Addendum # 2

Bid Opportunity: 25-7630-RFT - Laurentian Public School HVAC and Building Controls Upgrade

A202

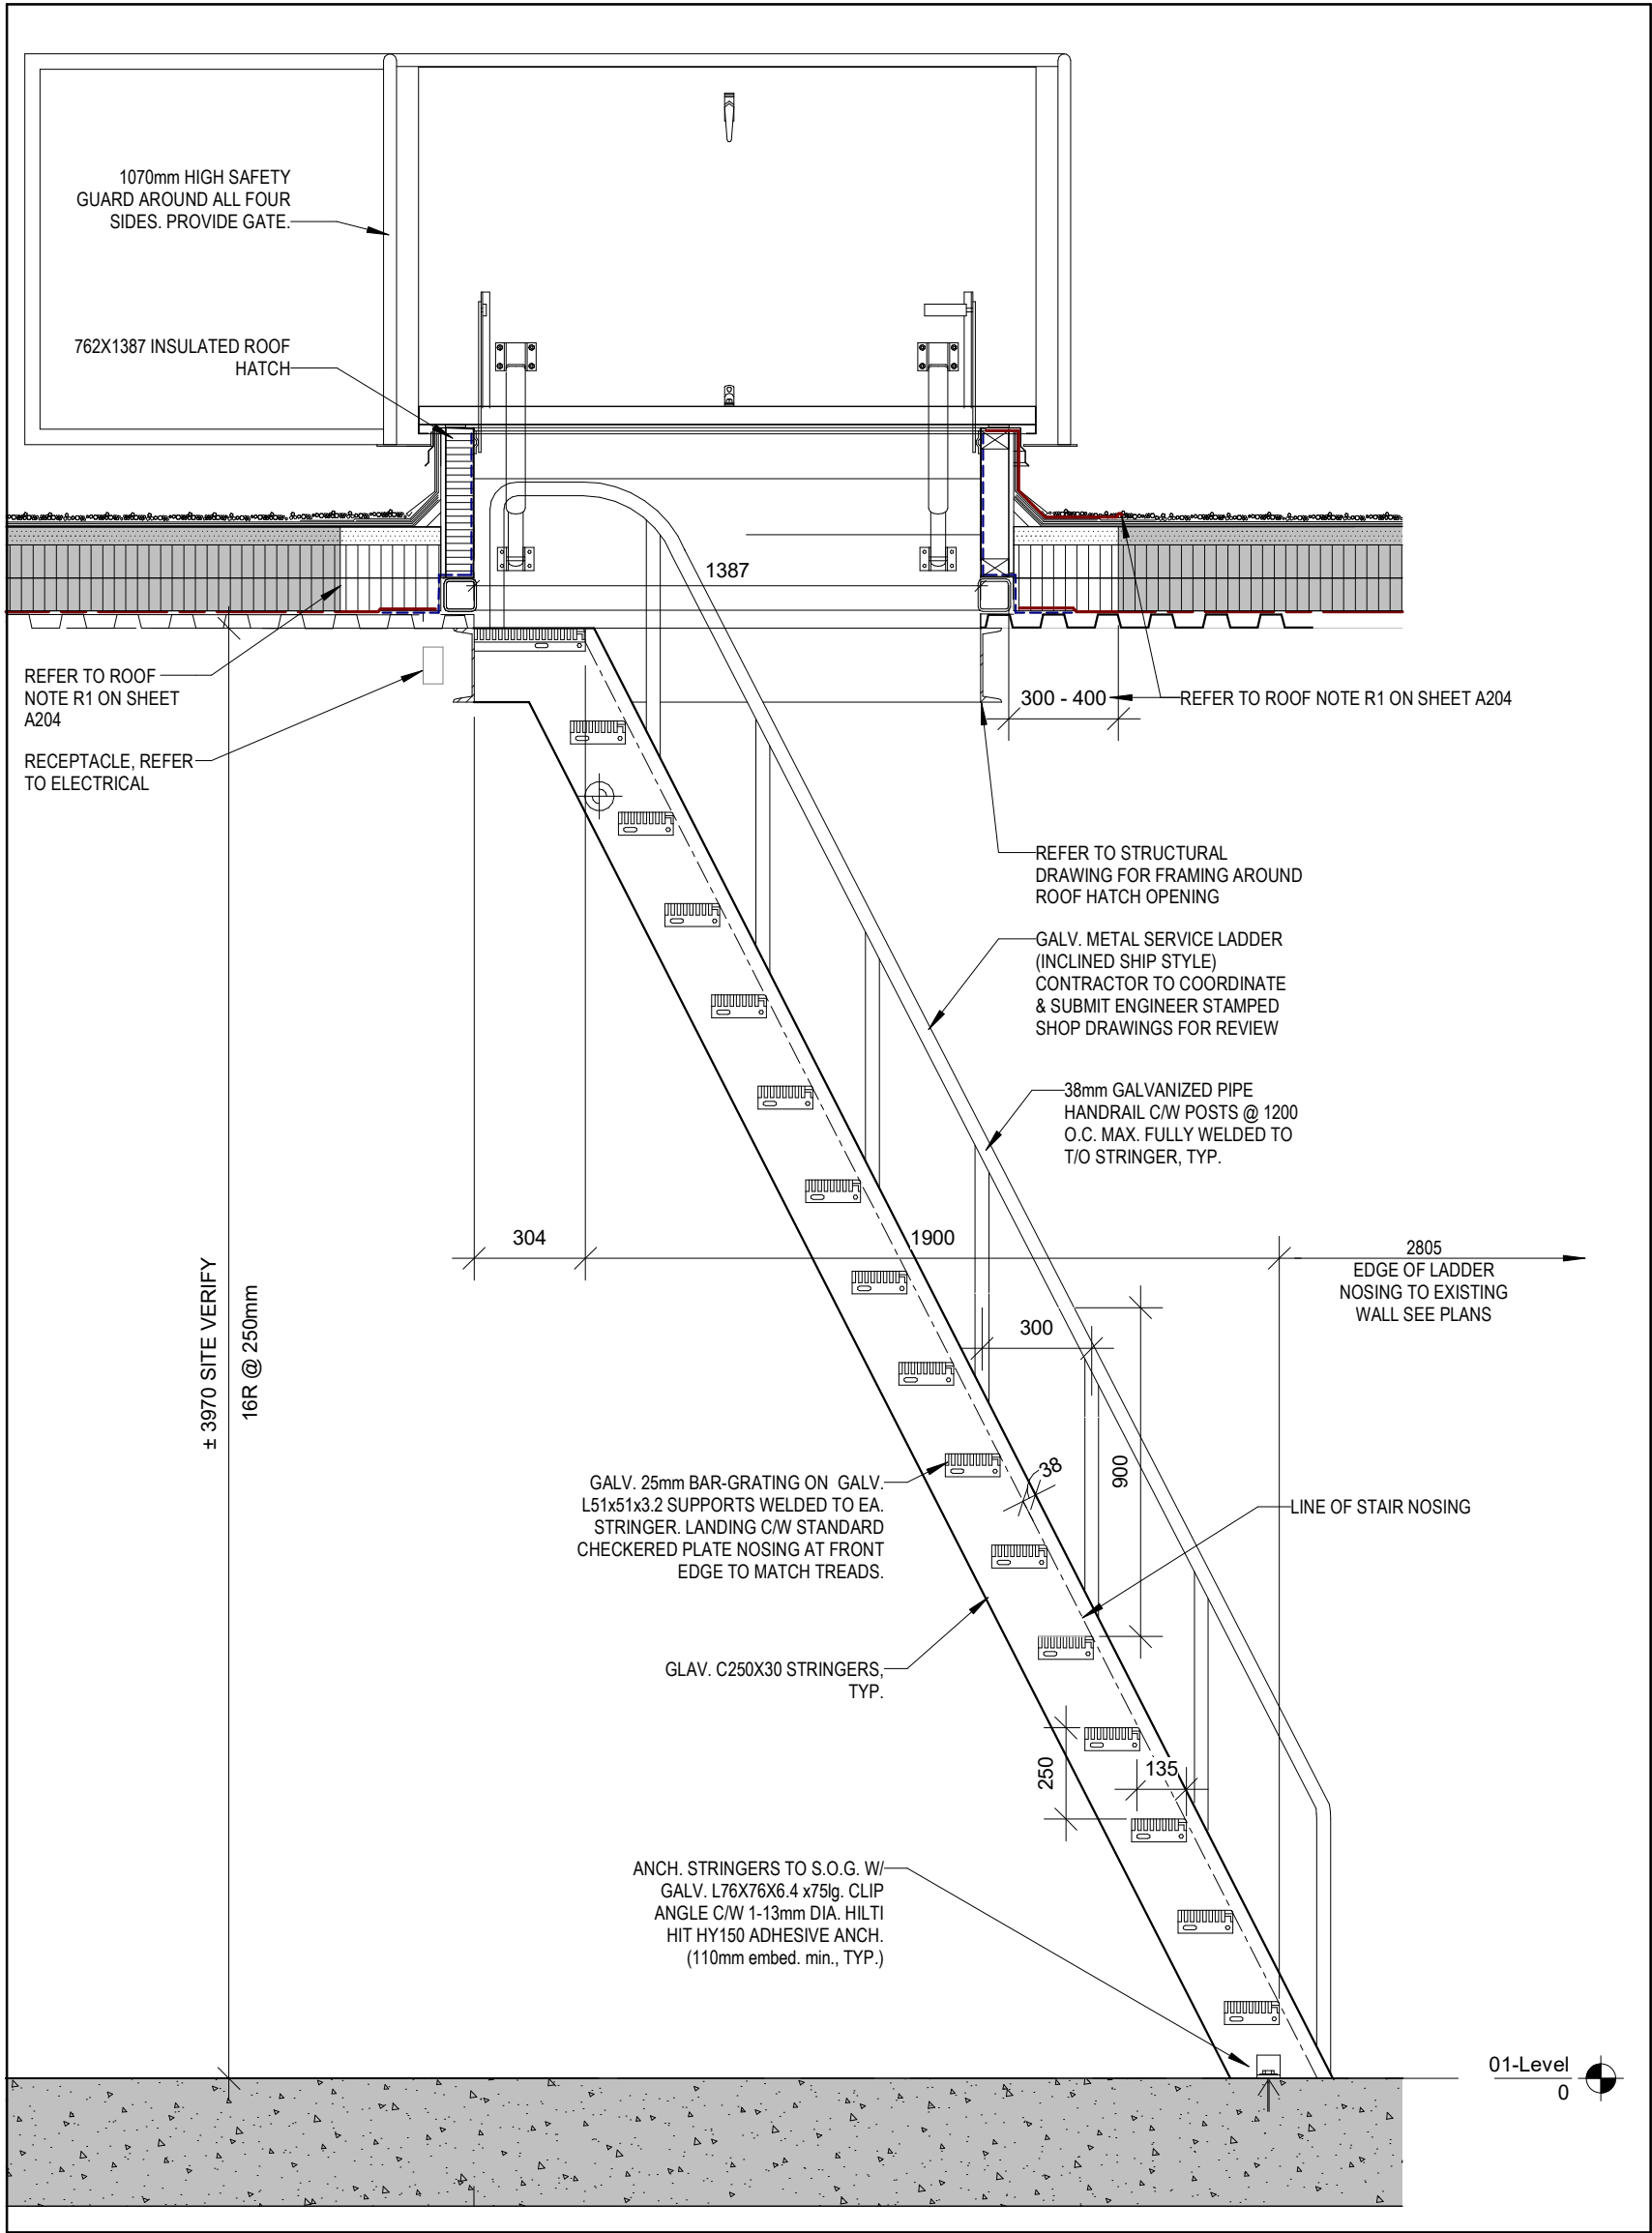
Delete reference to VCT1 from finish legend on A202.

Please provide a detail for note 12 on drawing A202. The structural and mechanical drawings do not have any details for this item.

Please provide a detail for the insulated panel louver infill note 13 on drawing A202 room D46.

Drawing A202 Partial Ground Floor Plan

1. In Science Room (17) added millwork elevation 2/A802. See attached drawing A201.
2. In Drawing Notes added drawing note 17 'Upon completion of wood floor re-finish, reinstall benches in same location. Reconnect electrical service. Refer to electrical drawing E501 for receptacle reconnect.'
3. In Science Room (17) added benches and drawing note 17.
4. Removed VCT1 from Finish Legend.

¼" thick plate to be used to cover existing duct openings being abandoned. Affix plate to existing concrete floor slab using ¼" concrete screws spaced at 6" minimum.

- UPON COMPLETION OF WOOD FLOOR RE-FINISH, REINSTALL BENCHES IN SAME LOCATION, RECONNECT ELECTRICAL SERVICE, REFER TO ELECTRICAL DRAWING E501 FOR RECEPTACLE RECONNECT.

2 SCIENCE ROOM - WEST MILLWORK ELEVATION
A802 Scale: 1 : 20

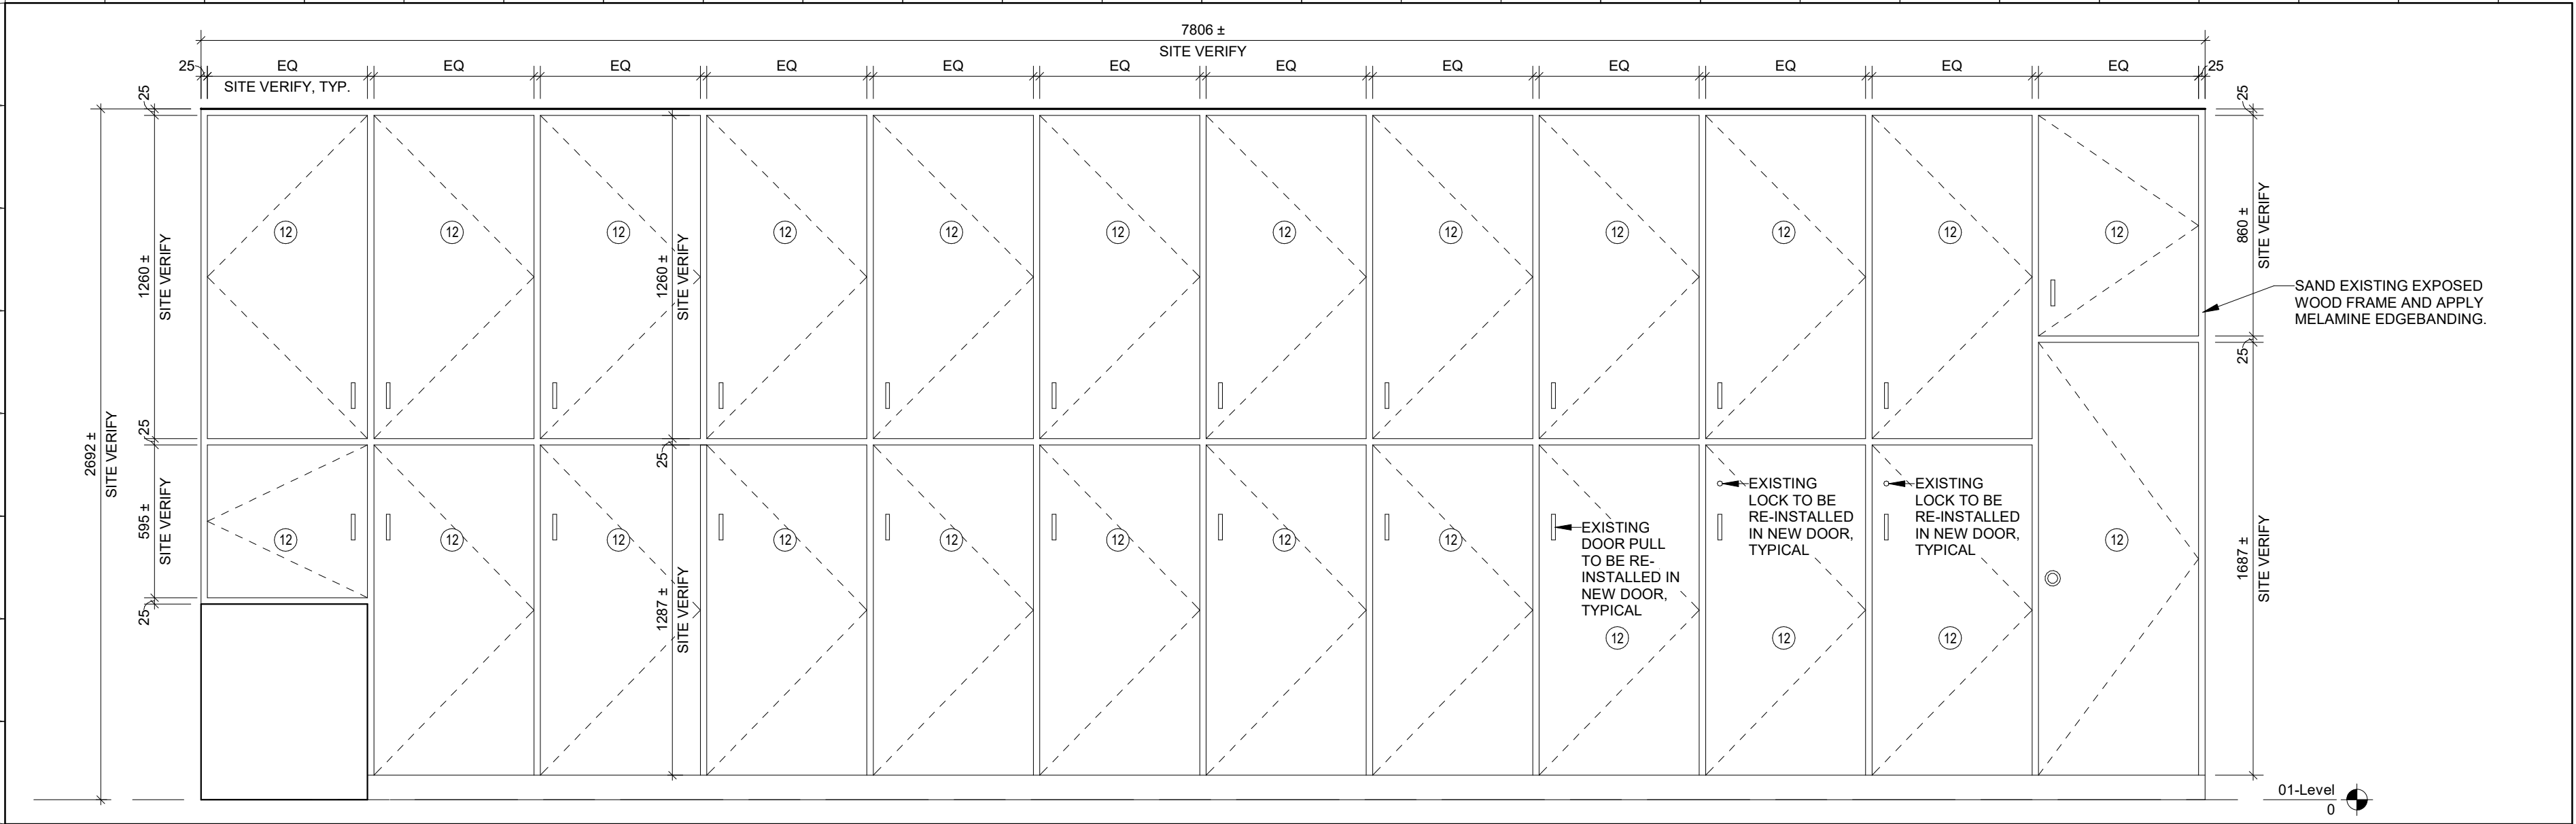
Please provide details and an elevation for the new millwork doors in the science room 17, see note 6 on 3-A202.

Drawing A802 Typical Details

1. Added 2/A802 'Science Room – West Millwork Elevation'
2. To Millwork Drawing Notes added drawing note 20 '19mm melamine door c/w 3mm PVC edge on all exposed edges. Re-install all hardware from existing millwork doors, including but not limited to door pulls, hinges and lock hardware.'

See attached for 2/A802 'Science Room – West Millwork Elevation'

- MILLWORK DRAWING NOTES:**
- 1 RECESSED SHELIVING PILASTERS
 - 2 19mm MELAMINE ADJUSTABLE SHELF WITH 3mm PVC EDGES.
 - 3 19mm POST FORMED PLASTIC LAMINATE COUNTERTOP.
 - 4 19mm MELAMINE DOOR C/W 3mm PVC EDGE ON ALL EXPOSED EDGES. PROVIDE LOCK - SCHLAGE CL100PB
 - 5 16mm MELAMINE BACK C/W 3mm PVC EDGE WHERE EXPOSED
 - 6 100mm HIGH RUBBER BASE TOE KICK (MATCH EXISTING) ON 19mm VENEER CORE PLYWOOD
 - 7 INTERMEDIATE CABLES 3-19mm PLYWOOD, MELAMINE ON ALL EXPOSED FACES WITH 3mm PVC EDGES.
 - 8 MILLWORK CHASE TO BE 19mm PLYWOOD, MELAMINE ON ALL EXPOSED FACES WITH 3mm PVC EDGES WITH 300mm X 300mm ACCESS PANEL
 - 9 STAINLESS STEEL SINGLE SINK
 - 10 FILLER PANEL
 - 11 COUNTER GRILLE, REFER TO SPECIFICATION
 - 12 19mm MELAMINE DOOR C/W 3mm PVC EDGE ON ALL EXPOSED EDGES. RE-INSTALL ALL HARDWARE FROM EXISTING MILLWORK DOORS, INCLUDING BUT NOT LIMITED TO DOOR PULLS, HINGES AND LOCK HARDWARE.
